Project	IEEE 802.16 Broadband Wireless Access Working Group < http://ieee802.org/16 >	
Title	Changes in 802.16e Working Document for SS Authorization via EAP framework	
Date	2003-10-31	
Submitted		
Source(s)	Ae Soon Park Seokheon Cho Sun Hwa Lim Young Jin Kim Jee Hwan Ahn ETRI 161 Kajong Dong, Yuseong Gu, Daejon, Korea.	Voice : +82-42-860-5172 Fax: +82-42-860-5471 mailto: aspark@etri.re.kr chosh@etri.re.kr shlim@etri.re.kr
Re:	This is a response to a Call for Comments IEEE 802.16e-03/23 on IEEE 802.16e-03/07r4	
Abstract	This document contains suggestions on the additions in IEEE 802.16e-03/07r4 that would help user authorization in EAP-TLS procedure.	
Purpose	The document is submitted for review by Handoff/Sleep mode Ad Hoc Group and/or by 802.16 Working Group members	
Notice	This document has been prepared to assist IEEE 802.16. It is offered as a basis for discussion and is not binding on the contributing individual(s) or organization(s). The material in this document is subject to change in form and content after further study. The contributor(s) reserve(s) the right to add, amend or withdraw material contained herein.

Changes in 802.16e Working Document for SS Authorization vi

Figure 97-b Authorization state machine flow diagram (open policy)

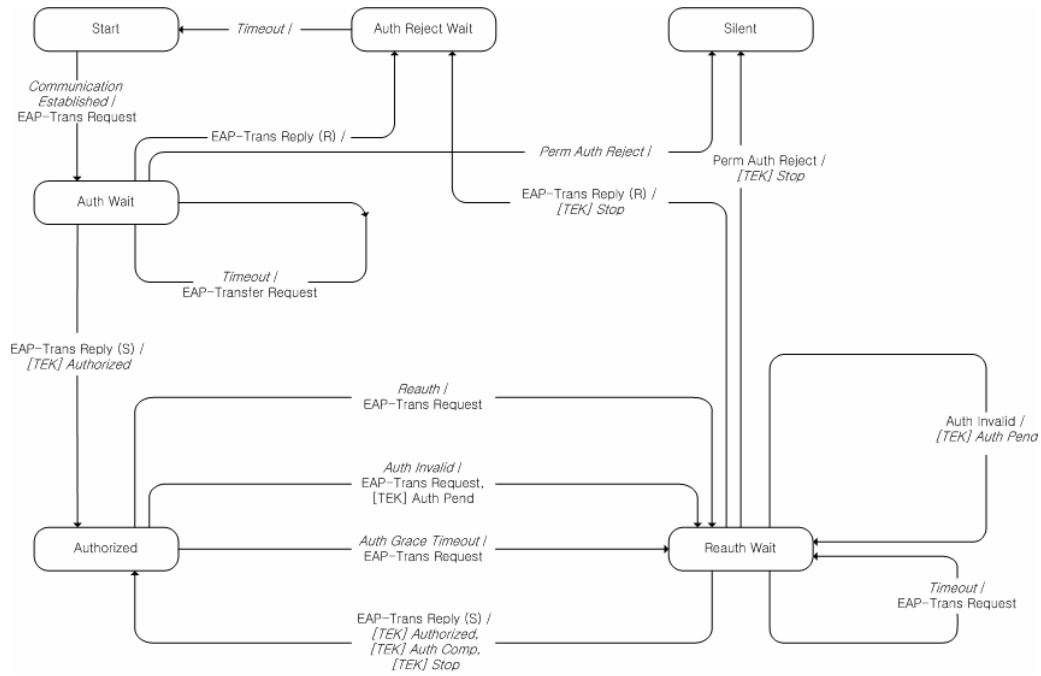
[Add Under Figure 97]

Figure 99—AK management in BS and SS

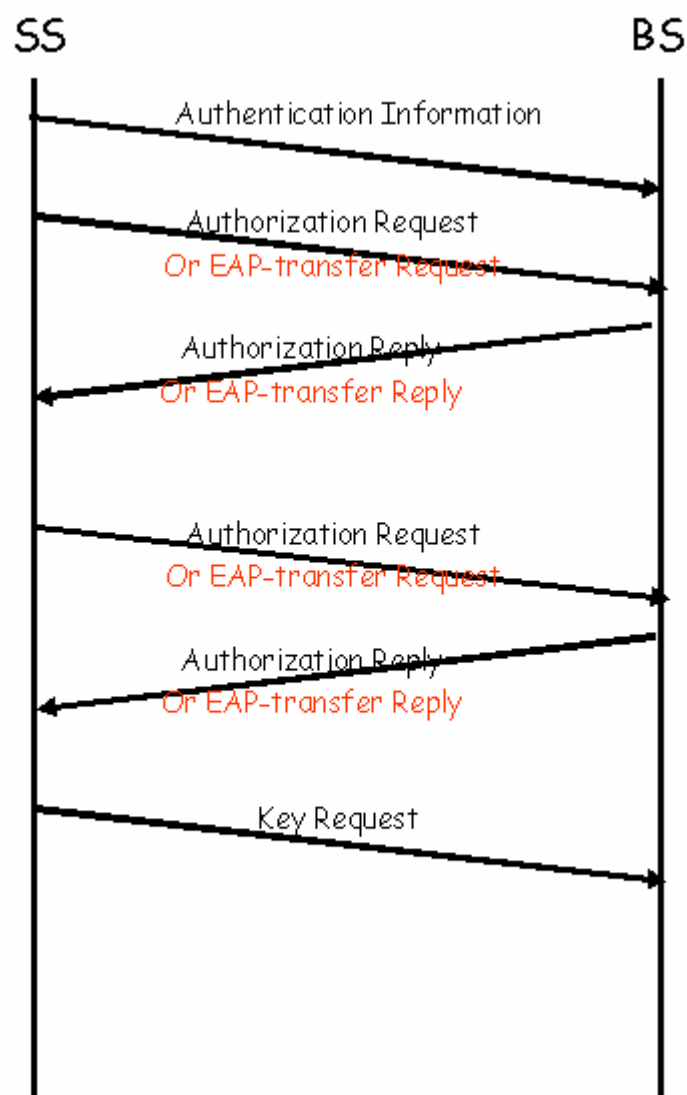
[in 7.4.1.2]

Figure 99 Modified
